We trust that these responses provide sufficient information to complete Revision 1 for the Preliminary Phase II RI Report. Please contact us if you have any questions regarding this response.

ENVIRON International Corporation

Revised Figures

**VERTICAL HYDRAULIC CONDUCTIVITY
OF THE AQUITARD
PHASE II REMEDIAL INVESTIGATION
DEPUE SITE
DEPUE, ILLINOIS**

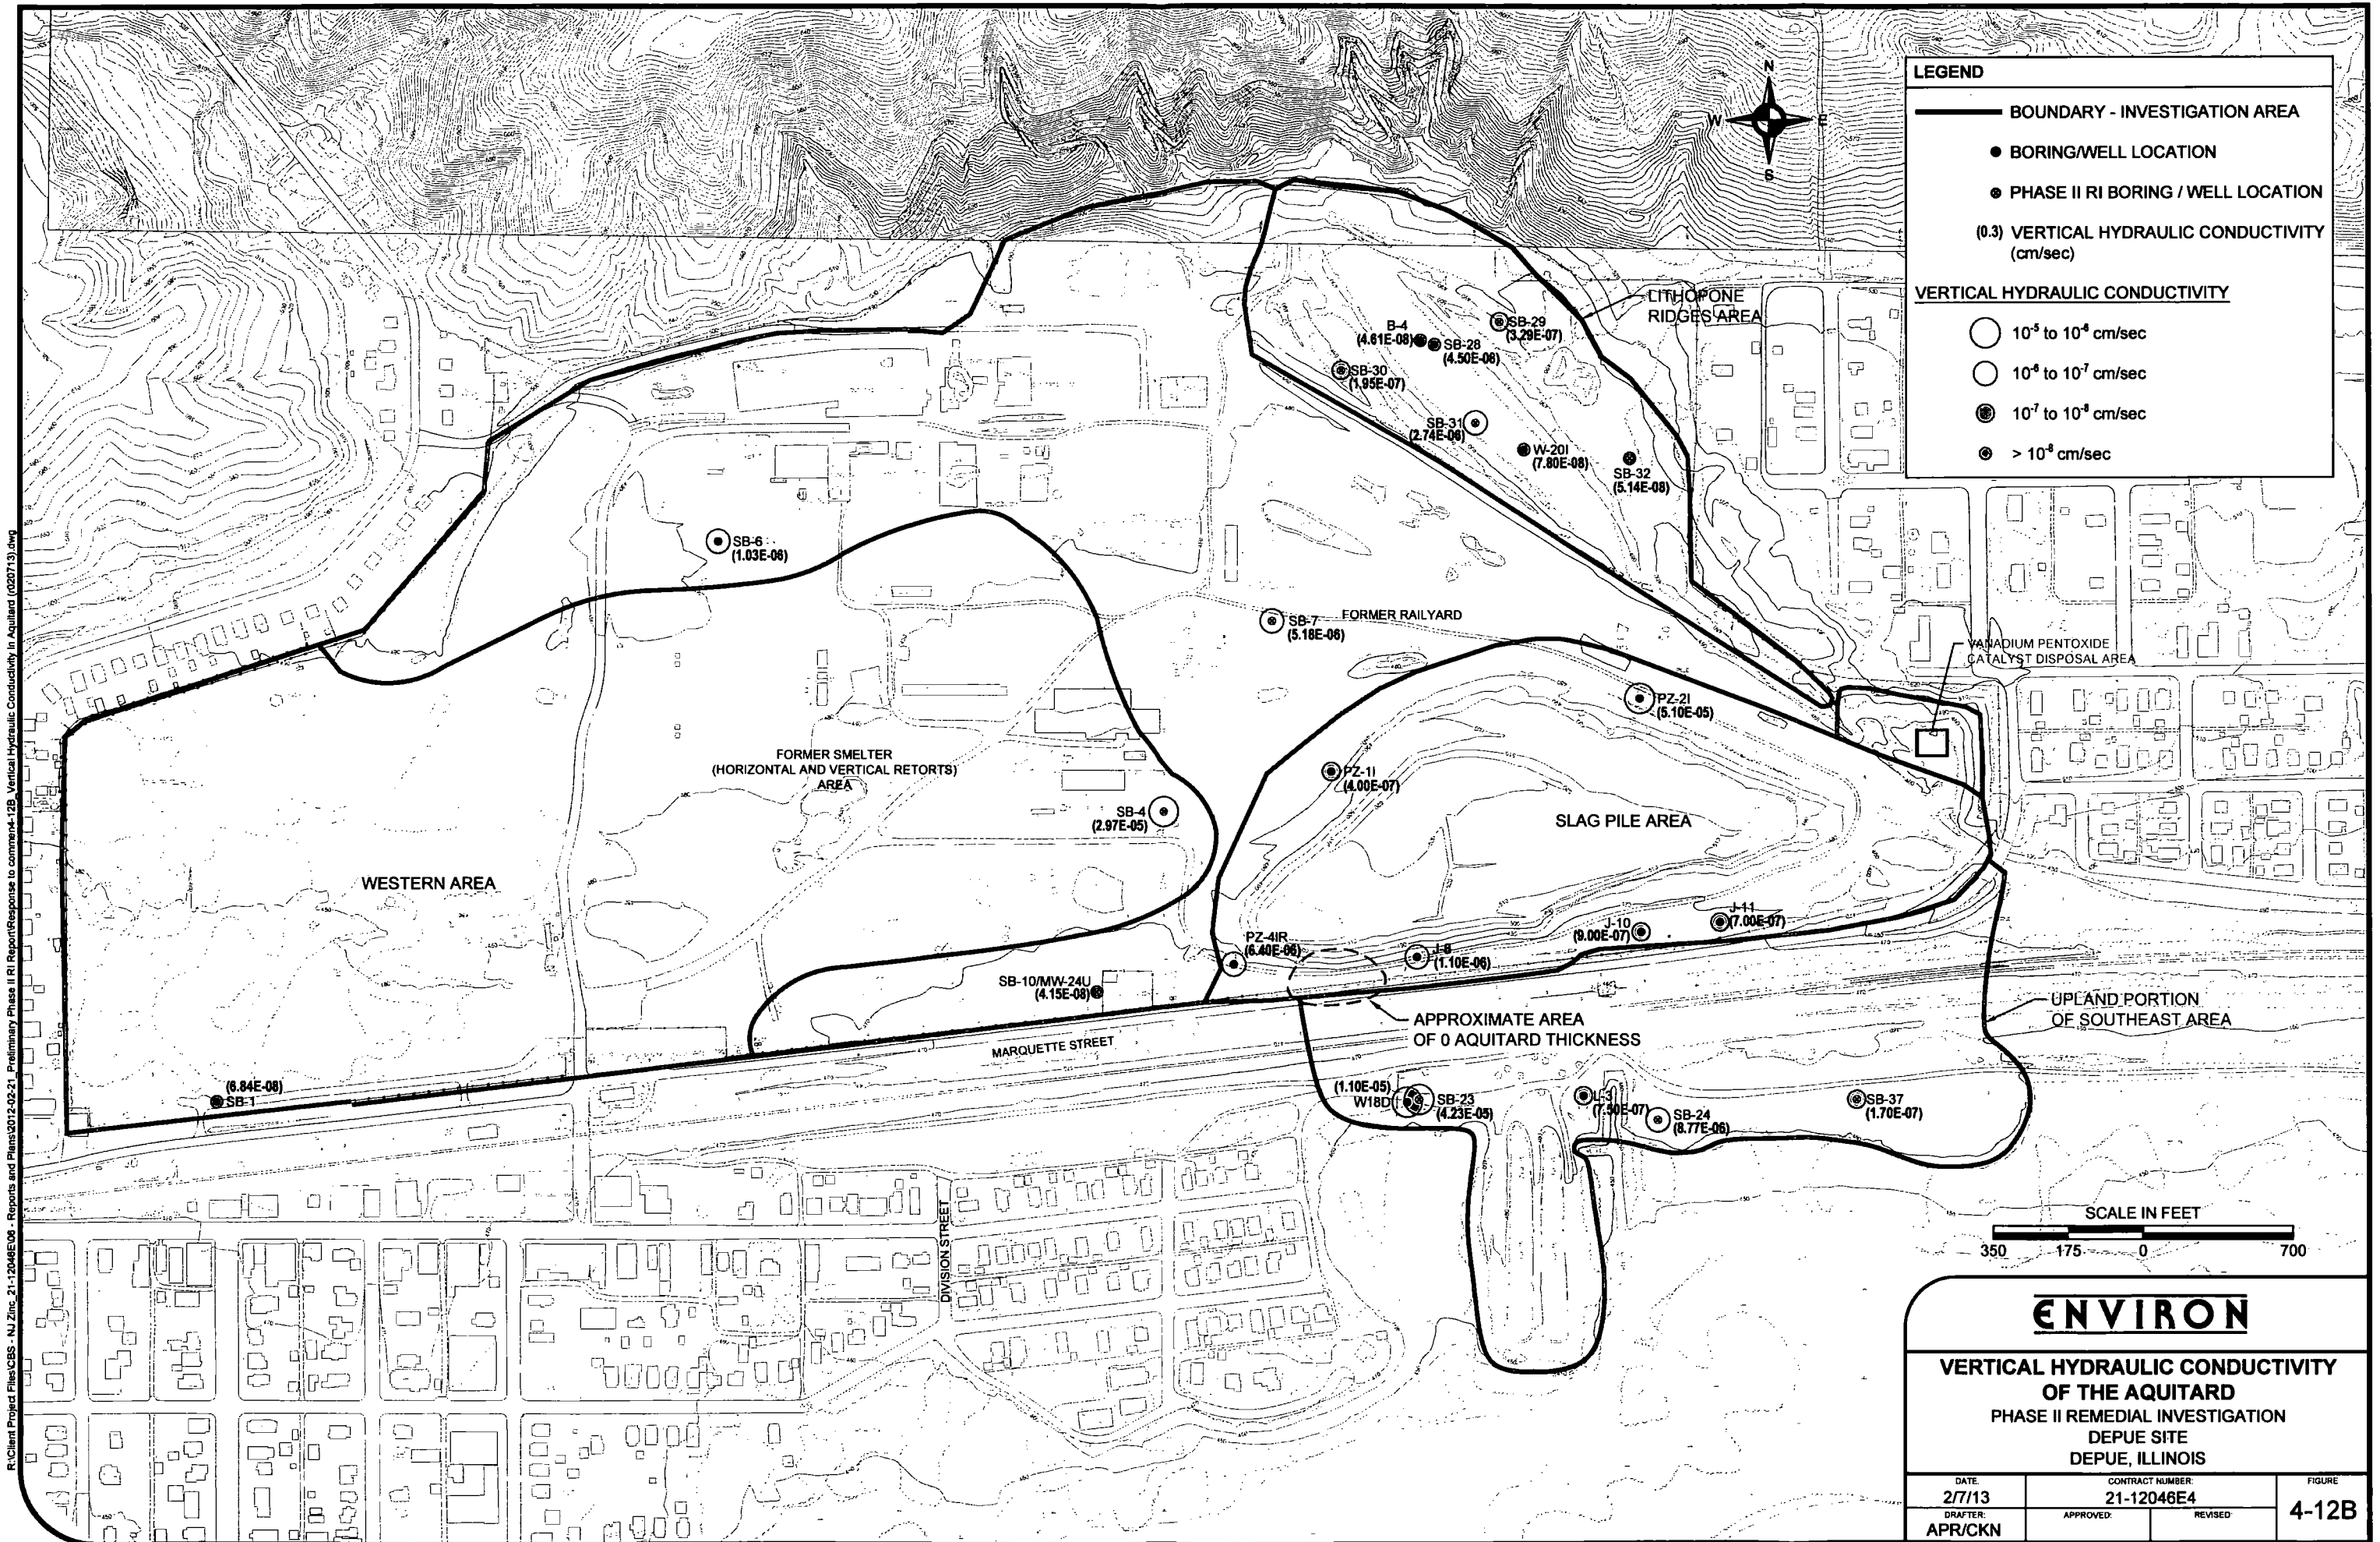
Illinois EPA Review: *Sufficient data has been collected to document the extent of the aquitard, as well as for determining the vertical hydraulic conductivities between the UWBZ and the Lower Aquifer. The primary issue is the presentation of that data in the report. The development of a contour map to show the spatial distribution of hydraulic conductivities across the site is a better tool to determine the locations of potential problem areas for contaminant migration, as well as for showing areas where the aquitard is absent than the use of laborious and obscure text. Currently, this information is poorly presented in the current Phase II RI Report figures, and text revisions proposed in the response to comments on this issue are not an improvement. Any inconsistencies between the aquifer thickness data in tables and what is currently shown on the figures also needs to be resolved.*

Review Response: We disagree that the text provided in the responses is laborious and obscure. As discussed in the responses above, not all data is suited for contouring, particularly in the instance of attempting to contour vertical hydraulic conductivity data of an aquitard layer that was deposited in an alluvial environment with order of magnitude variations in both long and short distances between sample points. Presenting this data with contours assumes that there is a gradient in the vertical conductivities from one point to the next, which is not an accurate assumption. Figure 4-12B has been prepared to provide a visual representation of the aquitard vertical hydraulic conductivities on a map. In addition, an updated Figure 4-7 has been prepared that uses contours instead of shading to depict the aquitard thickness as outlined in the response to comment 16.

**VERTICAL GROUNDWATER GRADIENTS BETWEEN
UPPER WATER BEARING ZONE AND
BOTTOM OF LOWER AQUIFER**

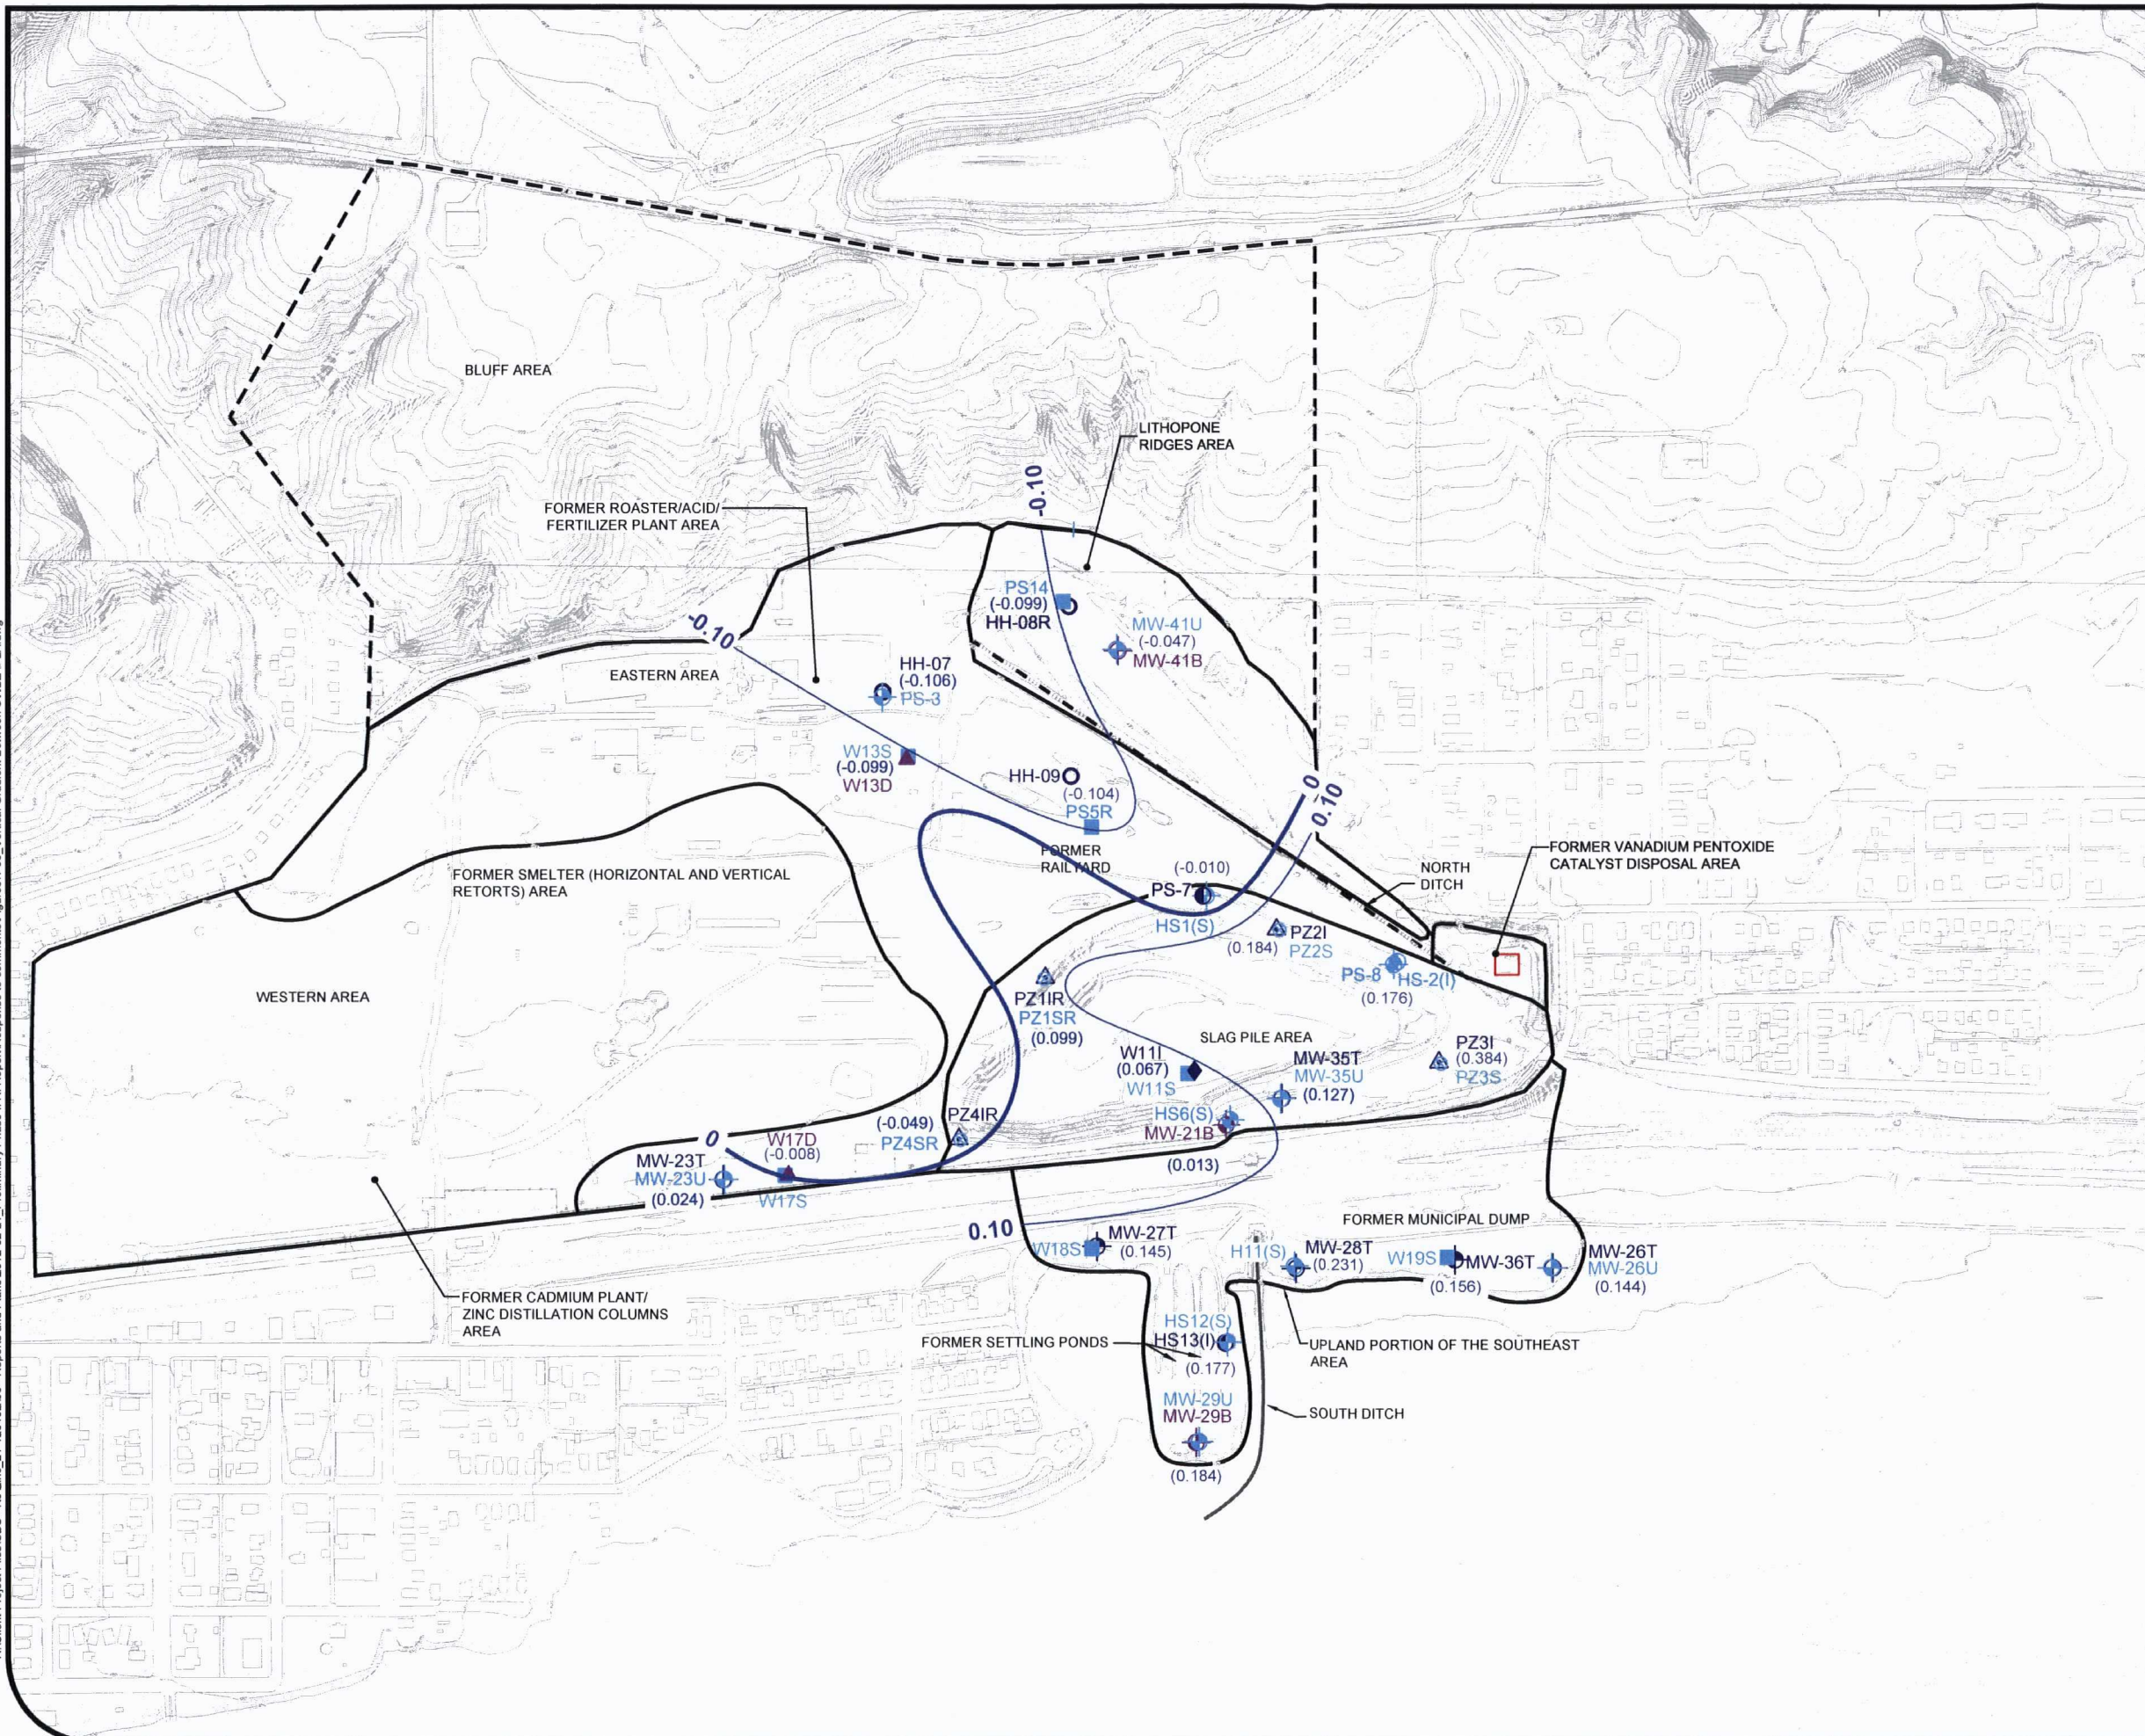
Comment 84 s) *With the exception of MW-48T/B, the vertical gradient within the Lower Aquifer in downward. At MW-48T/B it is suggested that the Lower Aquifer has some hydraulic connection with the abandoned former intake structure.*

Illinois EPA Review: *The revised text should address the effect of the abandoned former intake structure.*

Review Response: The following text has been added to the summary of vertical gradients: "The downward vertical gradient observed at MW-48T/B may be a result of the influence of the abandoned former intake structure."
